# Series 3.2 - 3 Port + Sound

Rev. 1.2 | 12/19/2016
David Kadish

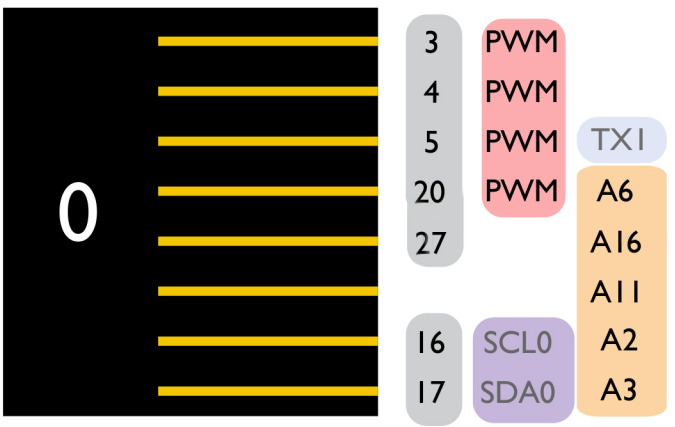
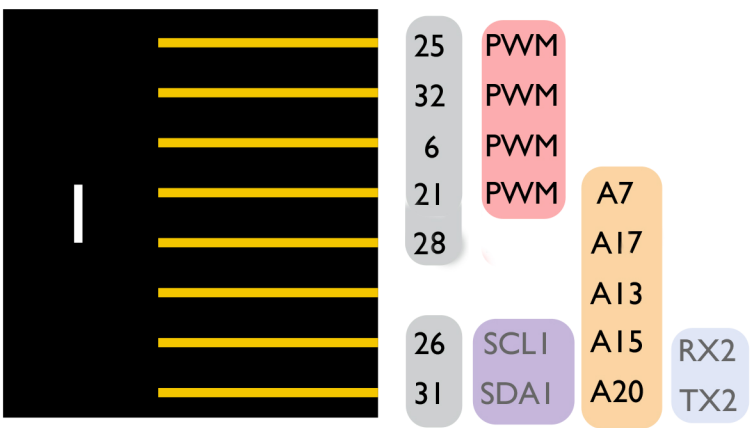
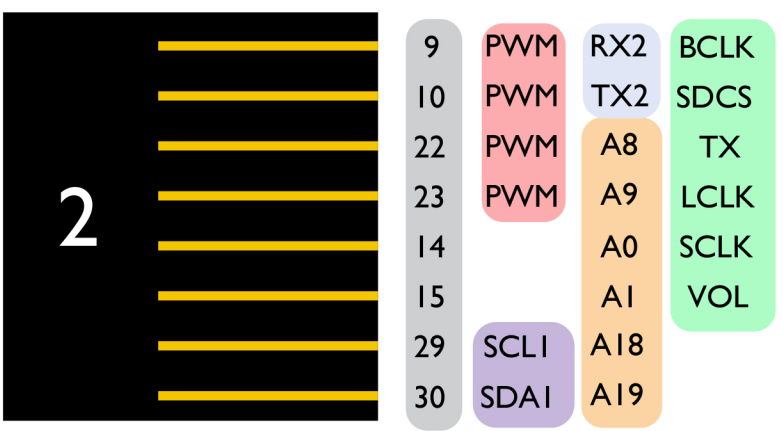
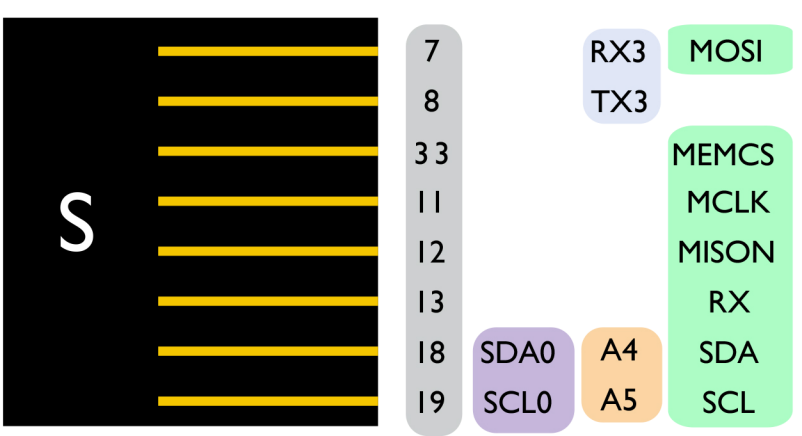
**Changelist:**
Moved 33 from 1-3 to S-3
Moved 6 from S-3 to 1-3

Renamed RX1/TX1 on S to RX3/TX3

Greyed out SCL0/SDA0 on 1

NB SCL1/SDA1 on 1 are not on official Teensy docs, but should still be present. They are discussed in the forums.
